ADDENDUM #: 2

PROJECT: Willits Veterans Hall Accessible Ramps

DATE: 9-8-2017

SHEET NUMBER:
**ADD 2.1
A102**

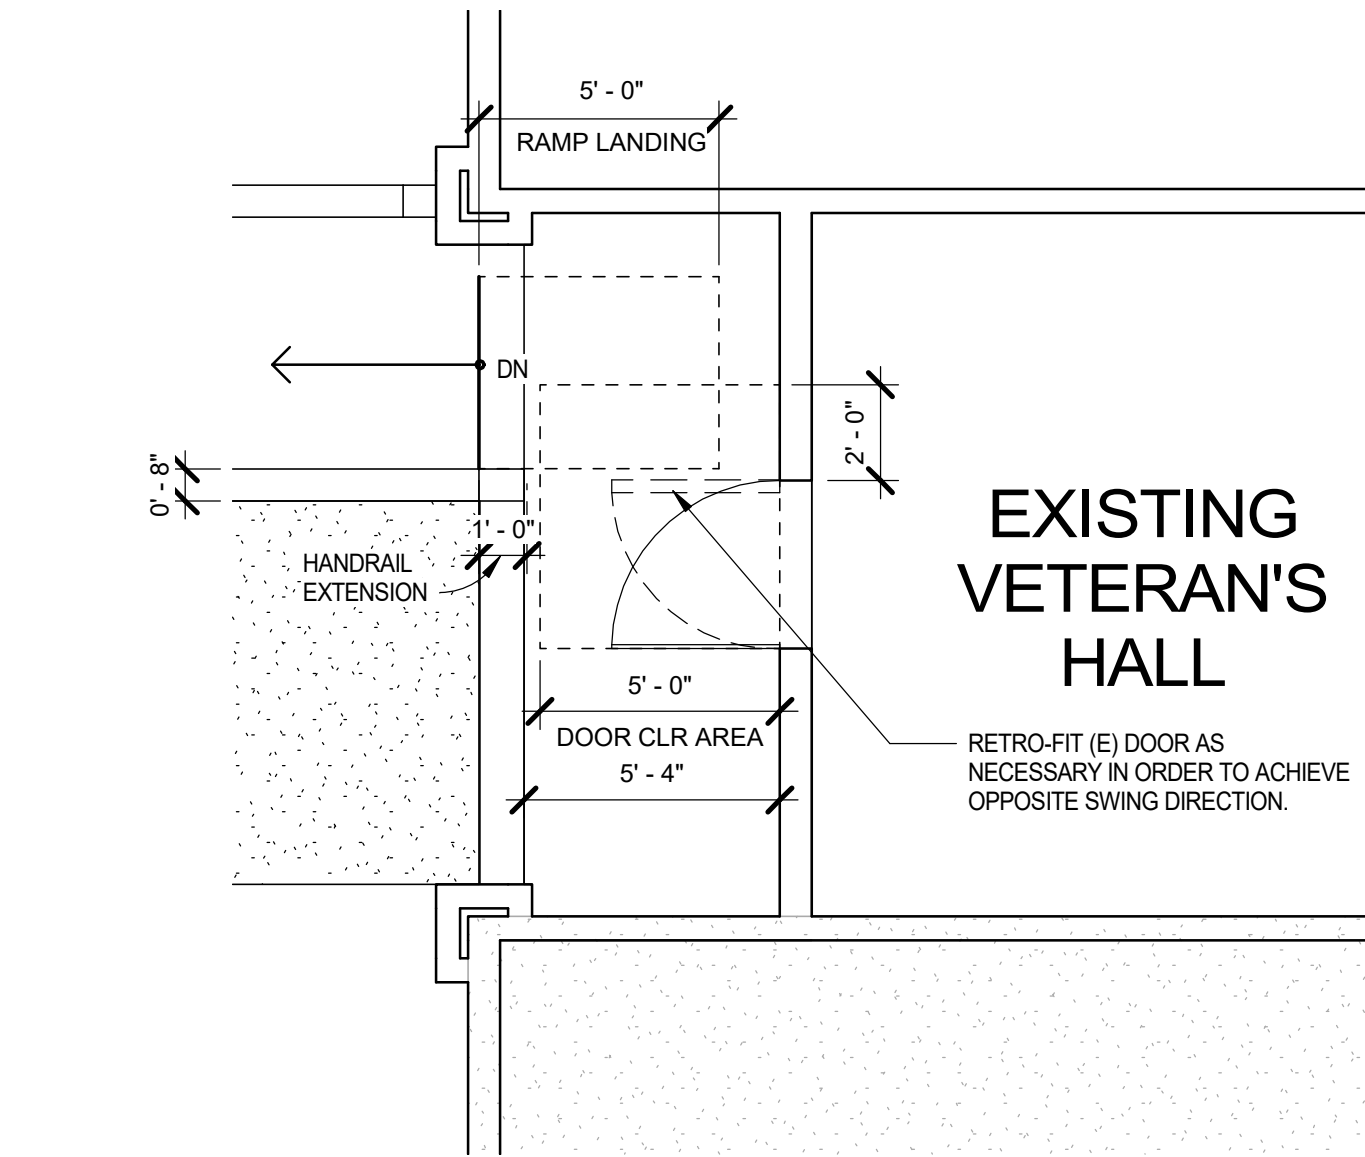
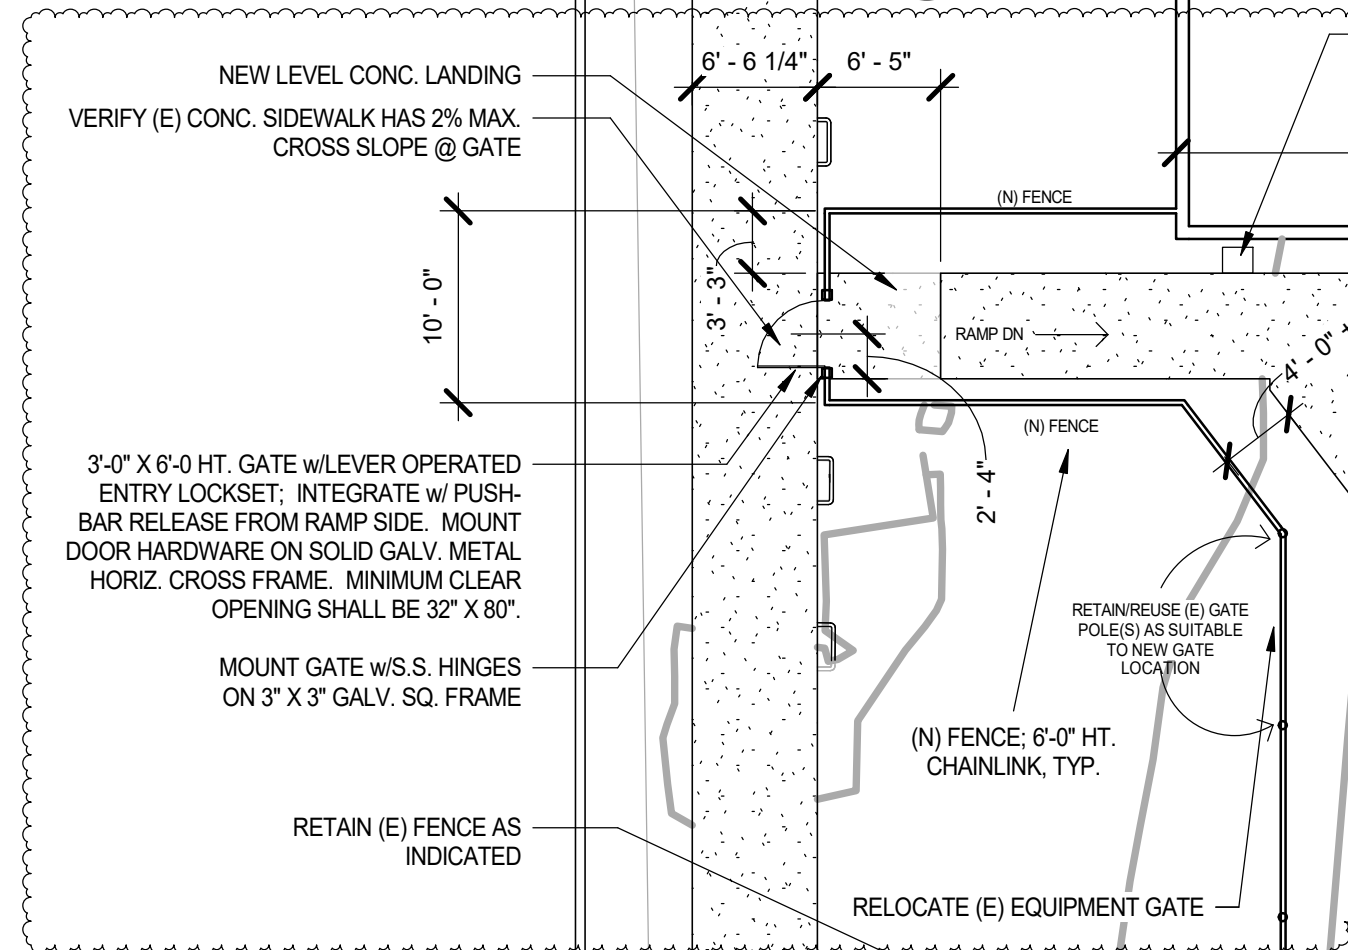
1. **Q:** New ramp passes through existing fence and gate, will the fence be abandoned or reinstalled at a different location?

3. **Q:** Existing gas line to the furnace unit and interior appliances is mounted to the (E) metal lean-to shed to be demolished, please provide direction for gas service.

Remove Plan Sheet A102 Site Plan-New and replace it with the attached ADD 2.1/A102 Site Plan-New.

A: Remove fencing as required to install ramp, provide new fencing and gates as shown in the attached sheet ADD 2.1

A: Intercept (E) gas service below grade outside excavations for new work; provide new gas line under slab. Provide (N) connection and SOV for relocated furnace and reconnect to existing through wall penetration. See attached sheet ADD 2.1
